## 1.0 SAFETY LIMITS AND LIMITING SAFETY SYSTEM SETTINGS

Omaha Public Power District  
Fort Calhoun Station-Unit No. 1

The changes to Section 2.0, "Limiting Conditions of Operation" incorporate the expected physics characteristics of the Cycle 8 core, the revised DNBR analysis and the use of the CE setpoint methodology previously used in the Cycle 5 analysis.

Figure  
1-1

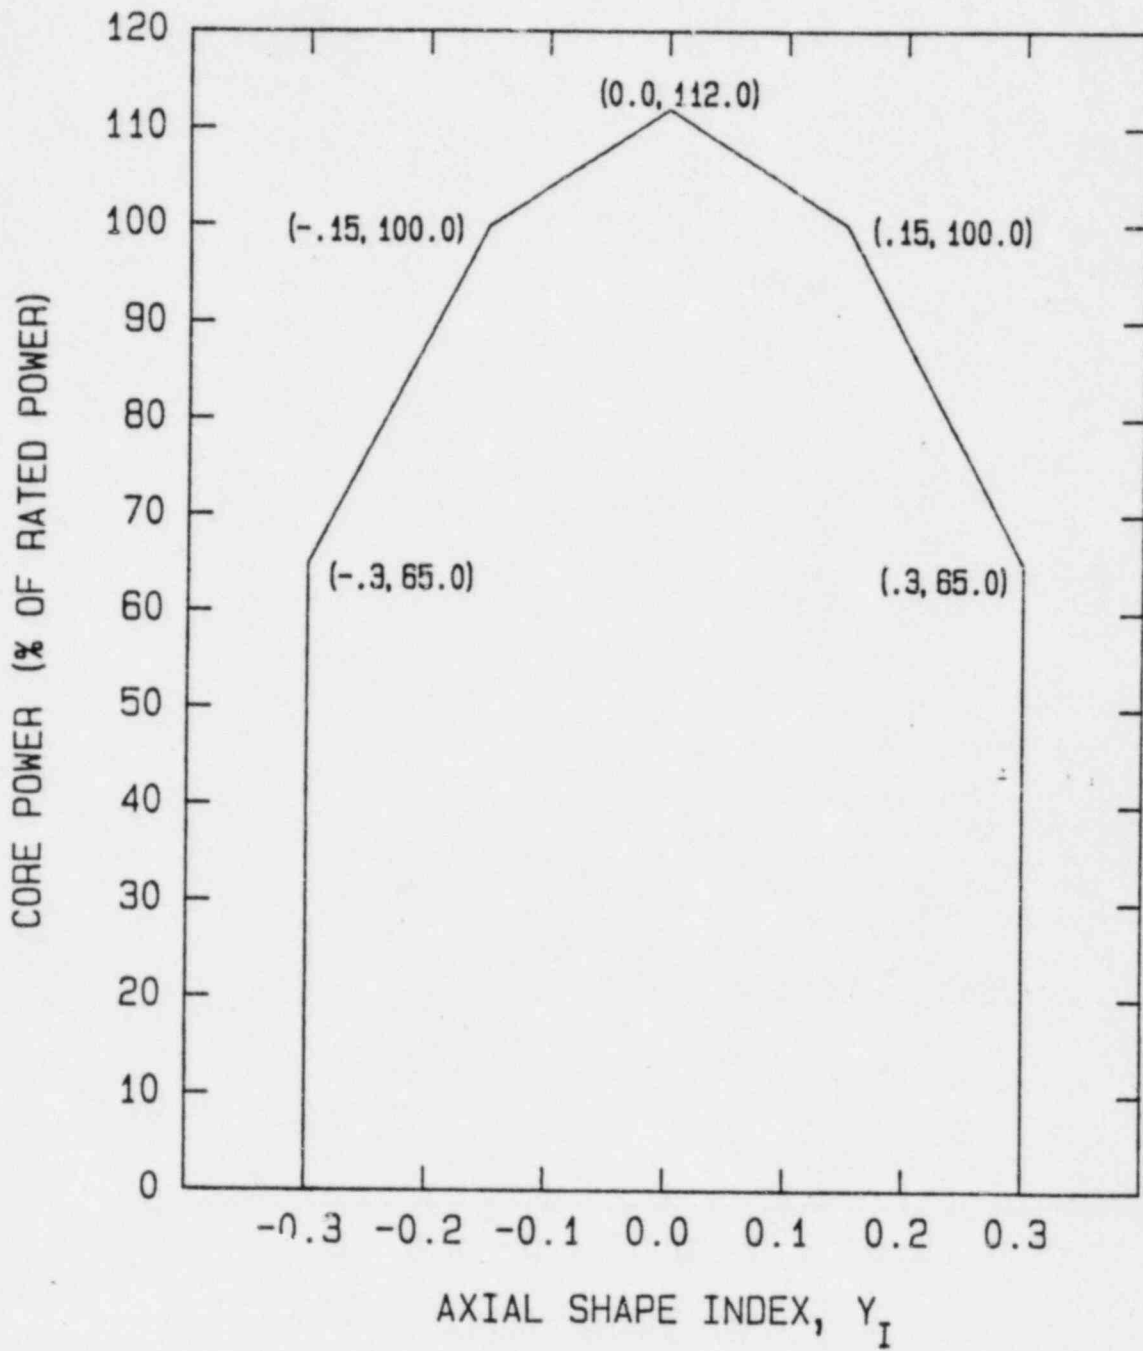
had been derived from the CEA Withdrawal Incident analysis, but the Cycle 8 analysis contained in attached USAR Section 14.2 demonstrates that the TM/LP trip is not required for the CEA Withdrawal Incident. The Axial Power Distribution LSSS, Figure 1-2, was changed to require more restrictive limits on the Axial Shape Index (ASI) at 100% of rated power to provide additional DNBR overpower margin. In addition, the lower power ASI limits are now more restrictive to be consistent with the constant ASI operating mode employed at the Fort Calhoun Station. The Thermal Margin/Low Pressure Safety Limit, Figure 1-1, has been revised and is consistent with the changes to Figure 1-3.

Figure  
2-6

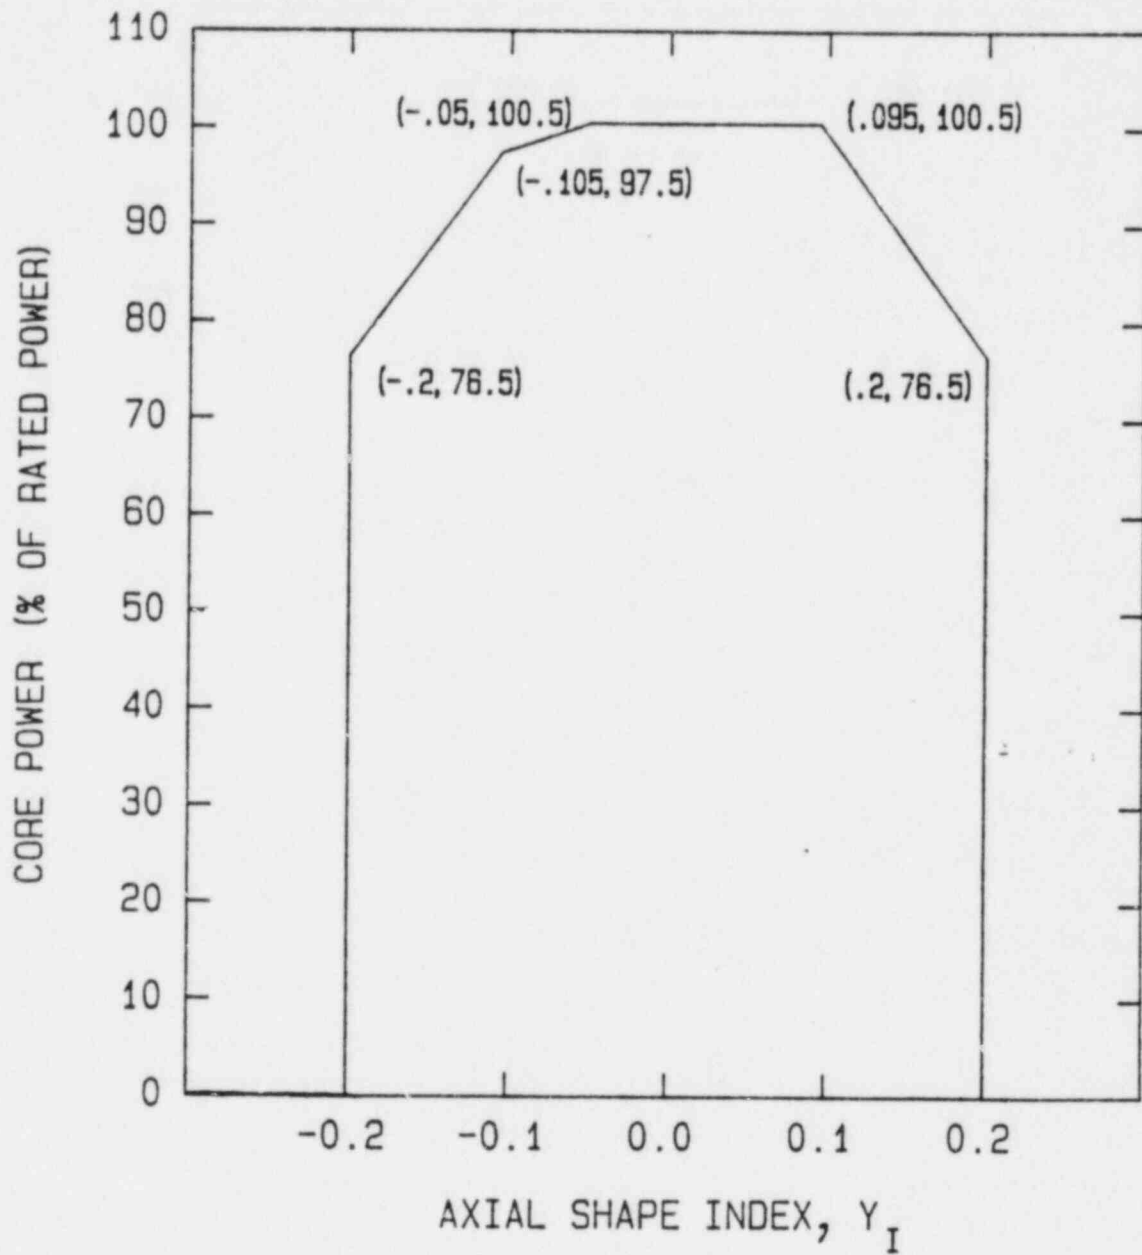
The Limiting Conditions for Operation for Excore Monitoring of Linear Heat Rate (LHR) Figure 2-6, has been revised at lower power levels to be consistent with Figure 2-7.

Figure  
2-7

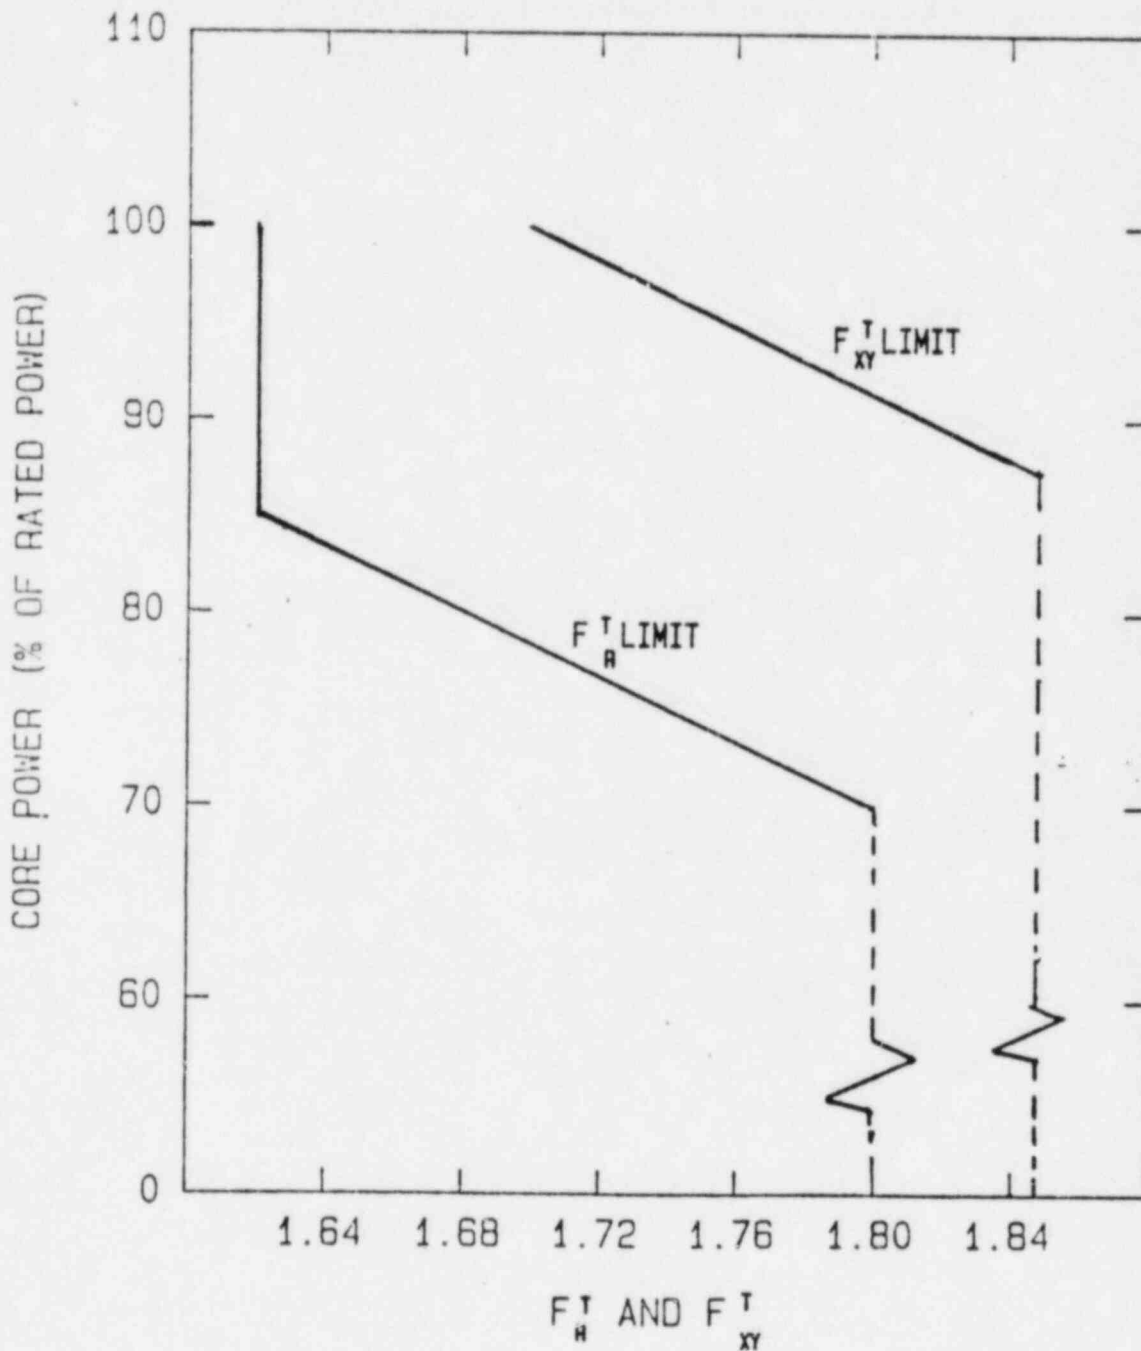
The DNBR Margin for operation above 15% of Rated Power, Specification 2.10.4(5), has been revised. Figure 2-7 has been changed at lower power levels to be consistent with the restrictions of Figure 1-2. The minimum reactor coolant flow has been increased to credit additional flow available from the Reactor Coolant Pumps.
